a **PCN 09\_0188 CERPAK AERO LASER BOTTOM BRAND**

**Comparison of Ink and Laser Bottom Mark**

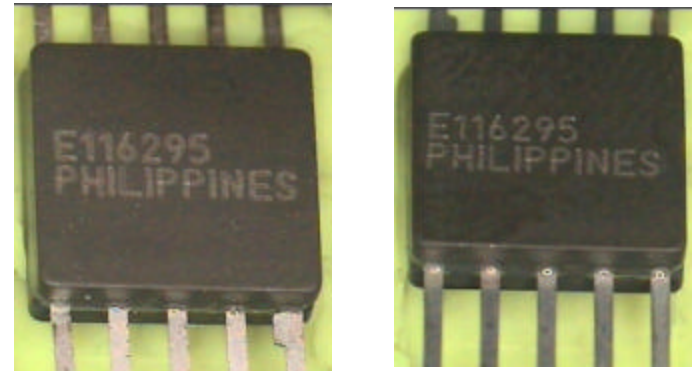
**From**

**Bottom Brand Ink Mark**

**To**

**Bottom Brand Laser Mark**
